SRT for 30-025-45459 Tubing Upsize

IPI request for 30-025-45459 & four additional wells after tubing upsize

WEU 527 Step Rate Test Overview

WEU 527 Step Rate Test Compared to Previous Step Rate Tests

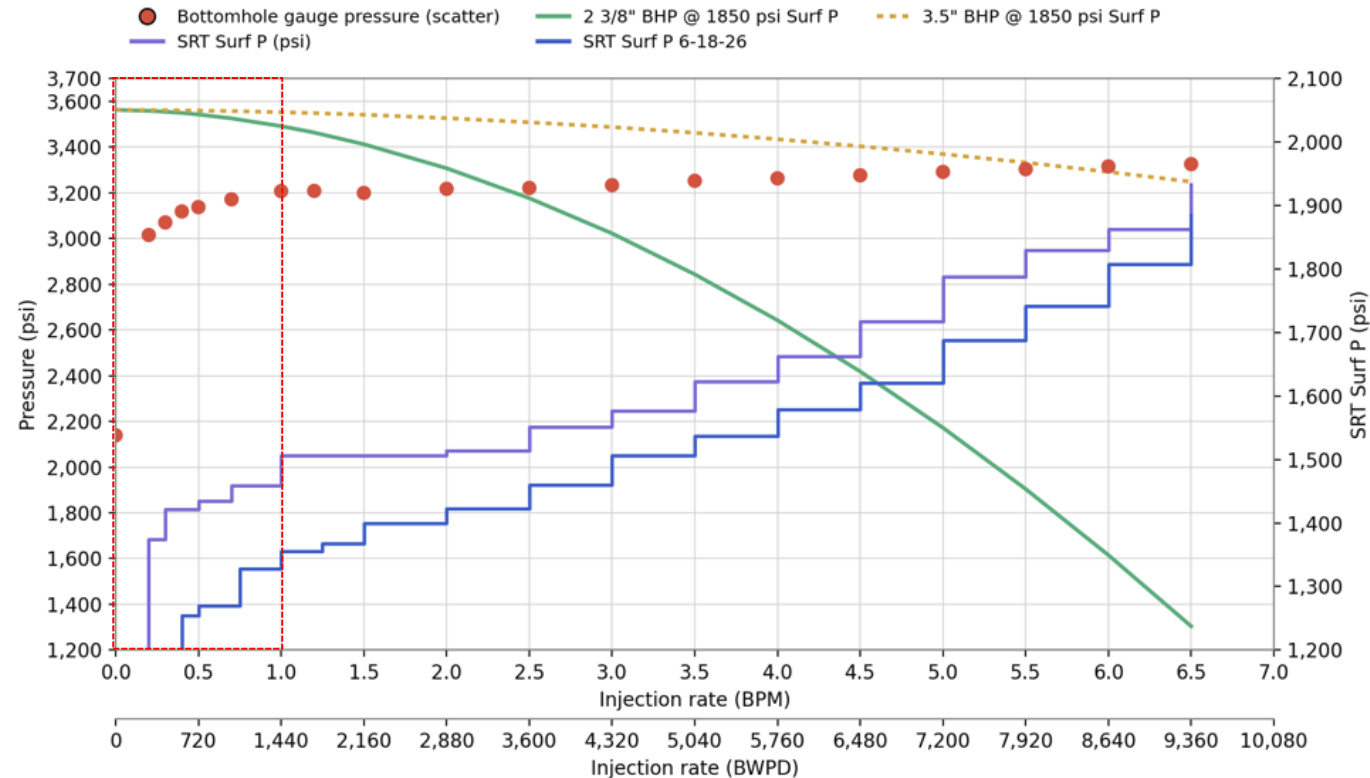
Result: No slope change

Result:
Slope change at ~1,850
psi surface pressure

Result: No slope change

- Reservoir pressure has increased dramatically due to the injection from the waterflood
 - Perf entry pressure rises with increased reservoir pressure
 - Perf entry pressure increased from ~2,450 psi to ~3,200 psi from 2020 to now
- F AE is seeing declining injection rates as we're limited by surface injection pressure as reservoir pressure increases
- F AE did not expect a slope change and did not see a slope change
- April 2026 SRT trend looks like March 2020 SRT trend
- The June and April 2026 step rate tests exhibit the exact same steady state slope.
- The June 2026 near wellbore reservoir pressure is lower vs April 2026 since we have not been able to inject due to the temporary lower allowable pressure being too low for us to inject water

WEU 526 (Pilot 2 Well) Current Surface Pressure Where Inj Rate = 0 bwpd

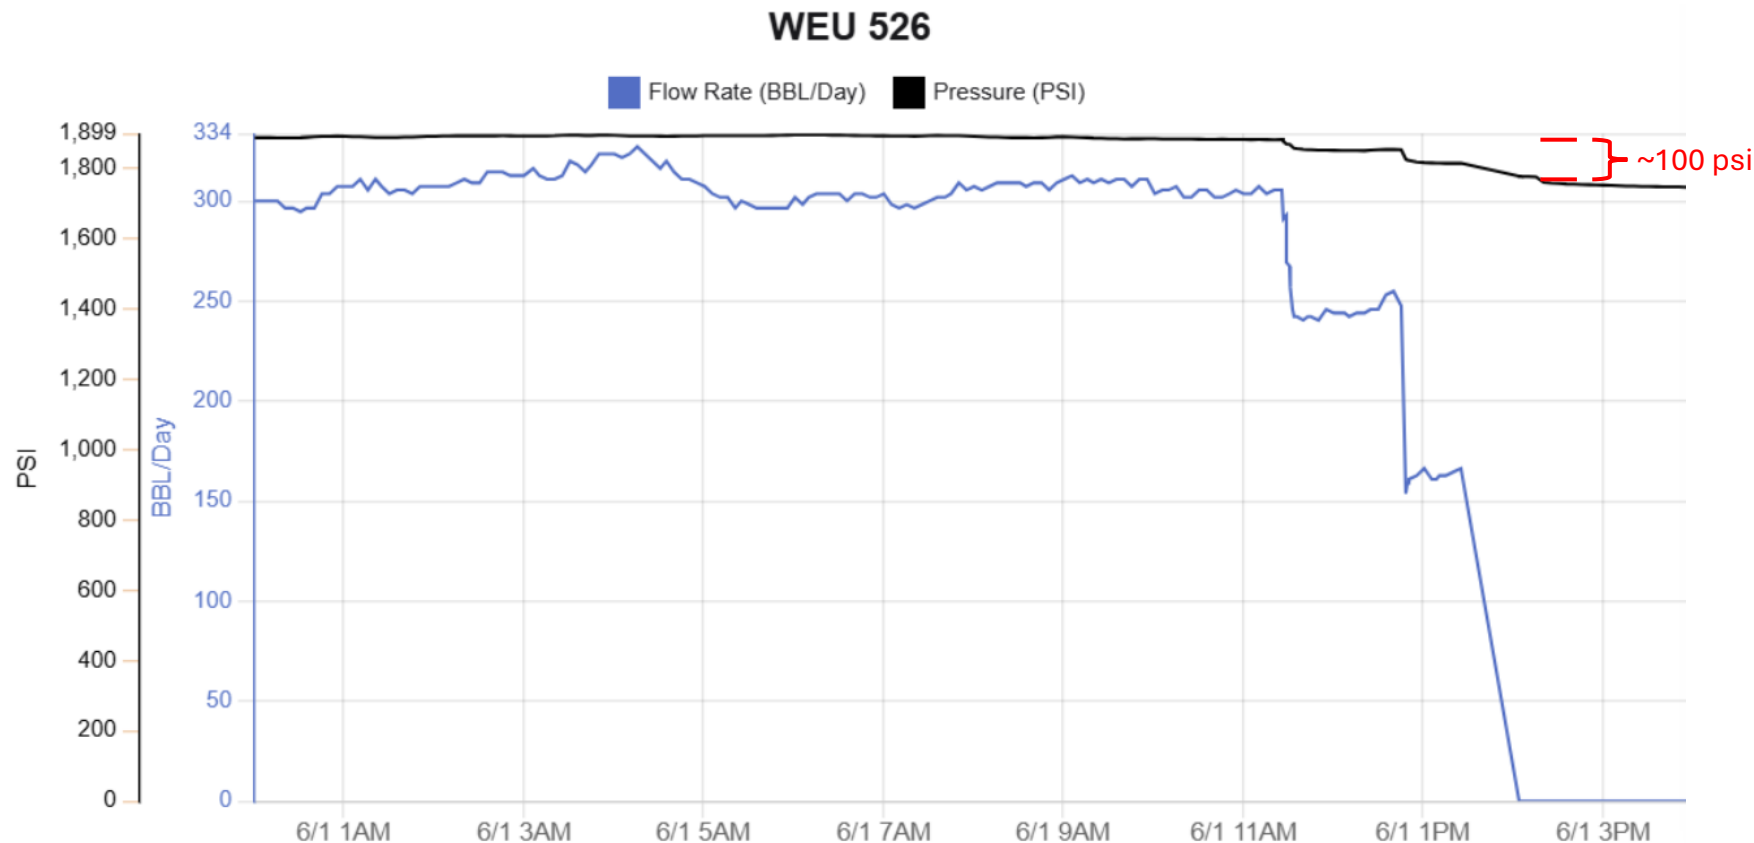
- Closest injector to the WEU 527 (step rate test well), ~1,240' from the WEU 527
- We currently inject at 1850 psi and 300 bpd
- At this rate, there is effectively no difference in friction pressure / BHP between 3 1/2" and 2 3/8" tubing
- At ~1,750 psi surface pressure, or ~100 psi lower than our current injection pressure, we found this well will go to 0 bwpd rate

WEU 524 (Pilot 2 Well) Current Surface Pressure Where Inj Rate = 0 bwpd

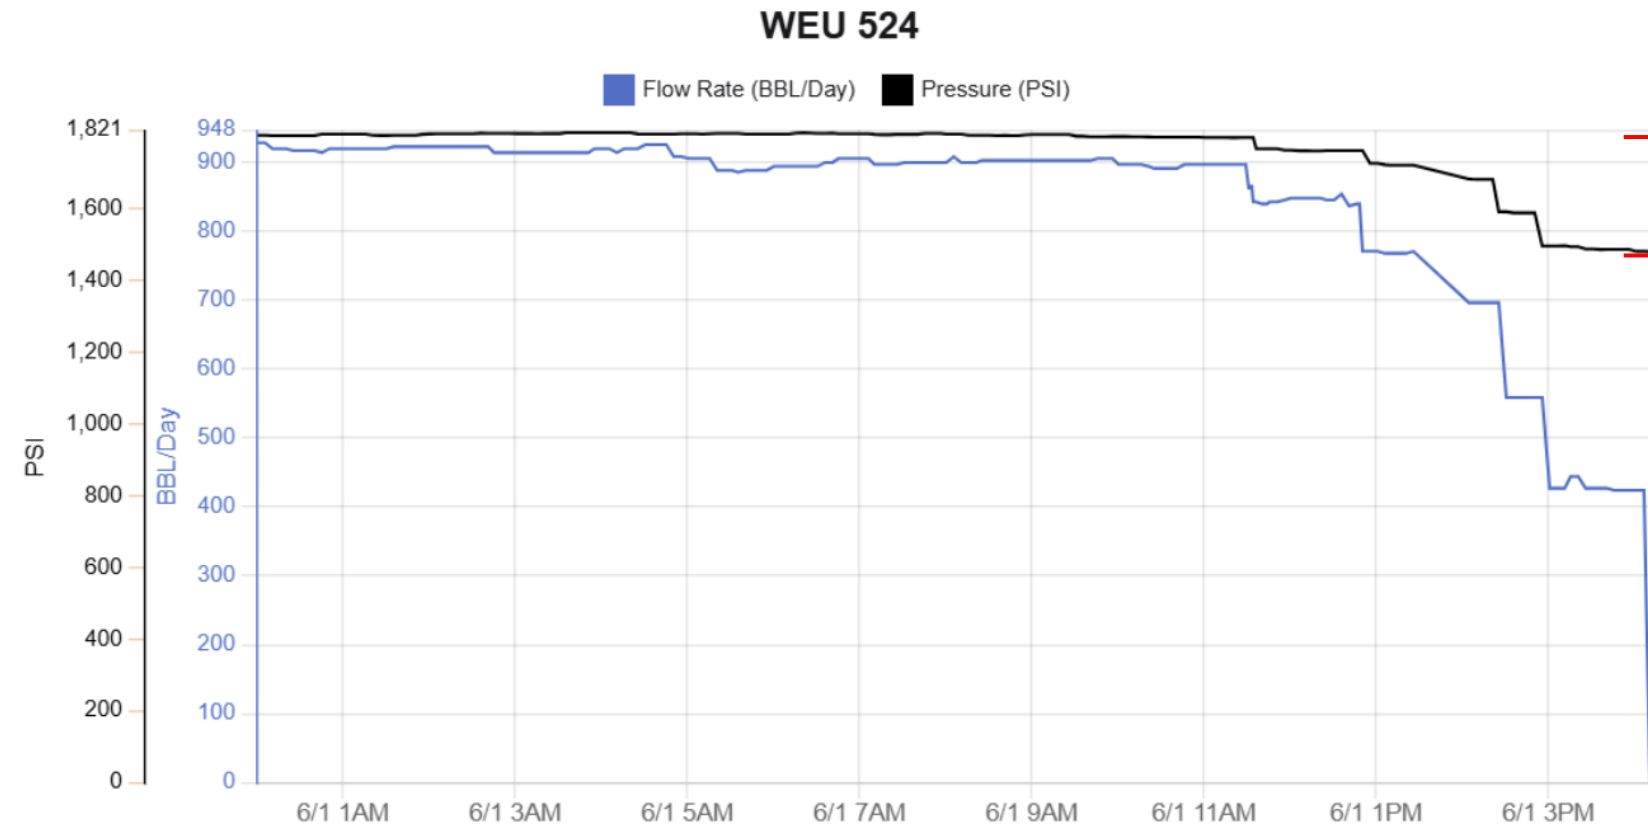
- 2nd closest injector to the WEU 527 (step rate test well), ~1,590' from the WEU 527
- We currently inject at ~1,800 psi and 900 bpd
- At this rate, there is very little difference in friction pressure / BHP between 3 ½" and 2 3/8" tubing
- At ~1,500 psi surface pressure, or ~300 psi lower than our current injection pressure, we found this well will go to 0 bwpd rate

WEU 525 (Pilot 2 Well) Current Surface Pressure Where Inj Rate = 0 bwpd

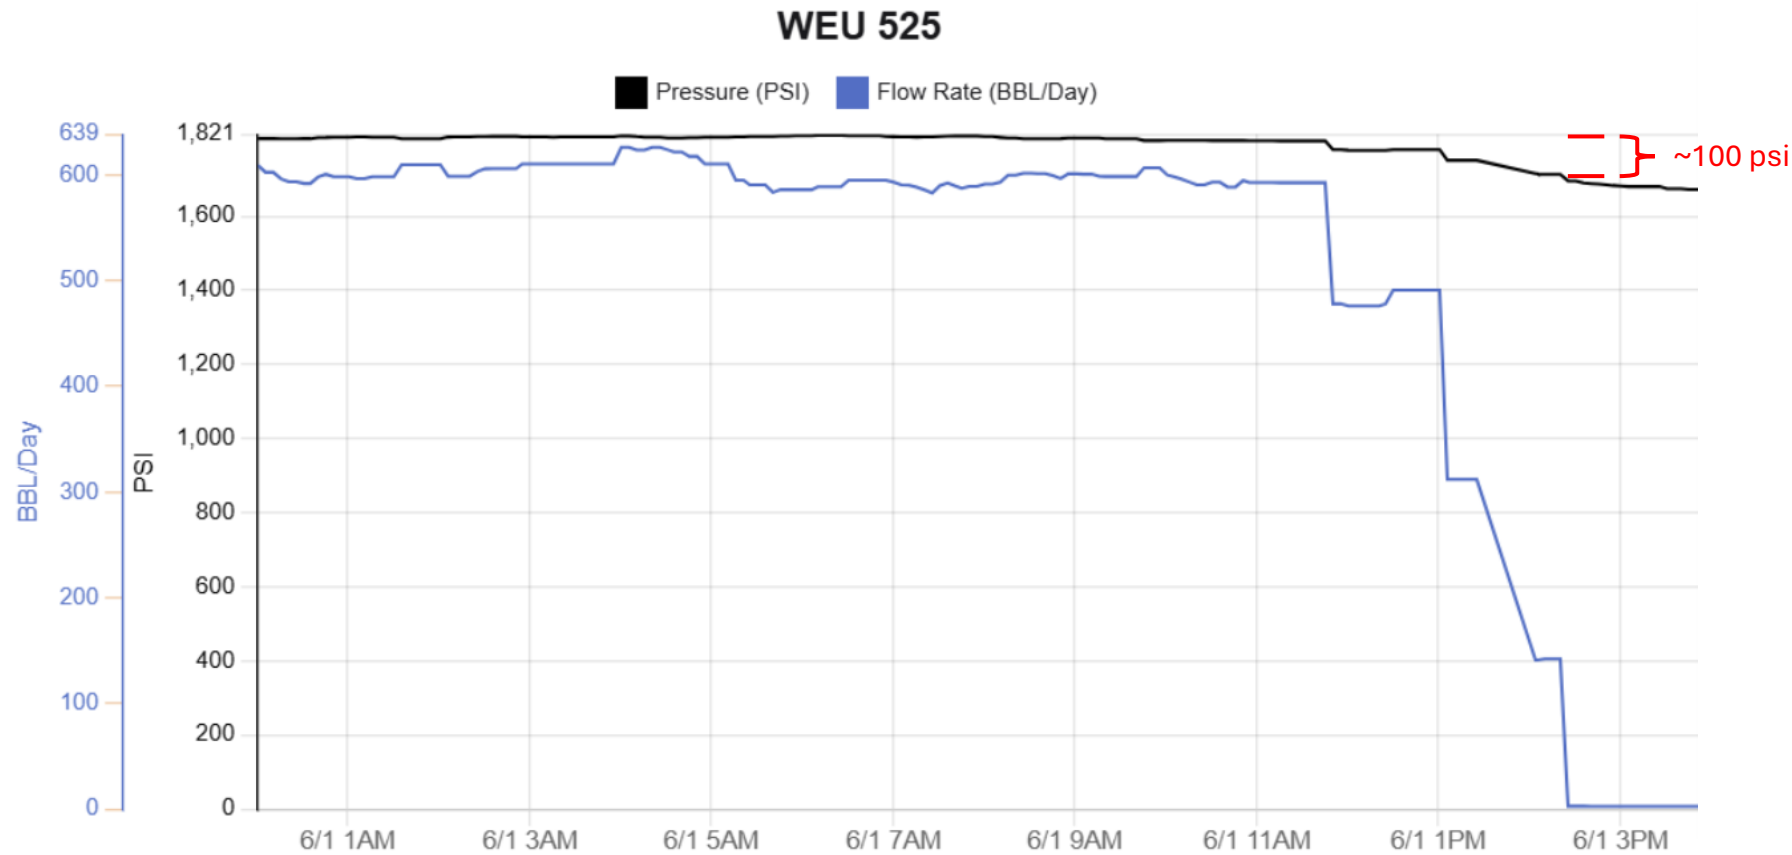
- 3rd closest injector to the WEU 527 (step rate test well), ~1,770' from the WEU 527
- We currently inject at ~1800 psi and 600 bpd
- At this rate, there is effectively no difference in friction pressure / BHP between 3 1/2" and 2 3/8" tubing
- At ~1,700 psi surface pressure, or ~100 psi lower than our current injection pressure, we found this well will go to 0 bwpd rate

WEU 527 Downhole Pressure Gauge Pressure Drop

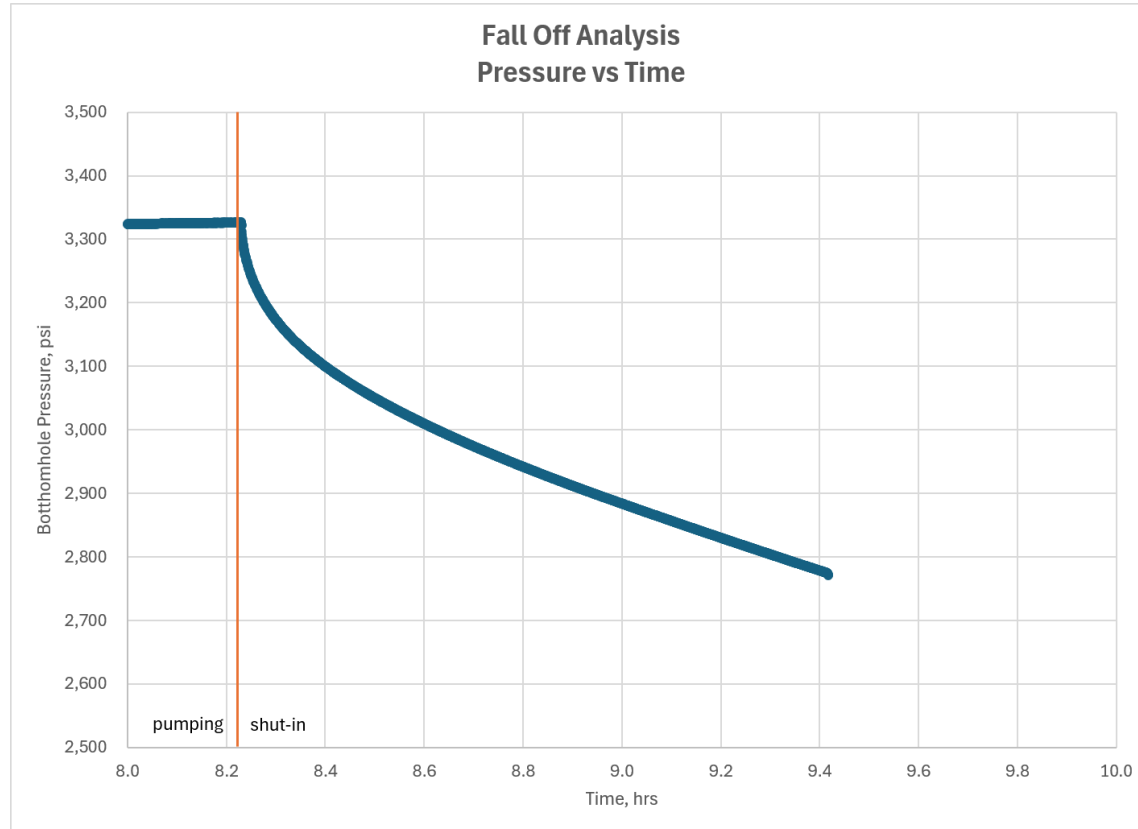
1. Can you please clarify how the bottomhole gauge was deployed / hung in tubing?

If option 1a or 1b was used, then the pressure recorded at the bottomhole gauge will not be truly representative of the pressure at the sandface since there would be a pressure drop due to the restriction associated with placement of the gauge inside the tubing.

- Liquid Orifice Pressure Drop
 - The downhole gauge is 1.25" diameter while the tubing ID is 2.992"
 - Units
 - $Q = 6.5 \text{ BPM} = 273 \text{ GPM}$
 - $C_d = 0.62$ (sharp-edged, the gauge is actually rounded, so would be more like 0.7-0.8, but will assume sharp)
 - $D_{\text{pipe}} = 2.992''$
 - $D_{\text{obstruction}} = 1.25''$
 - $SG = 1.0$ water
 - Solve
 - $d = \sqrt{2.992^2 - 1.25^2} = 2.72''$
 - $C_v = 29.8 \times 0.62 \times 2.72^2 = 136.7$
 - $DP = (273/136.7)^2 \times 1.0 = 3.99 \text{ psi}$
 - Total pressure drop due to the downhole pressure gauge is 4 psi
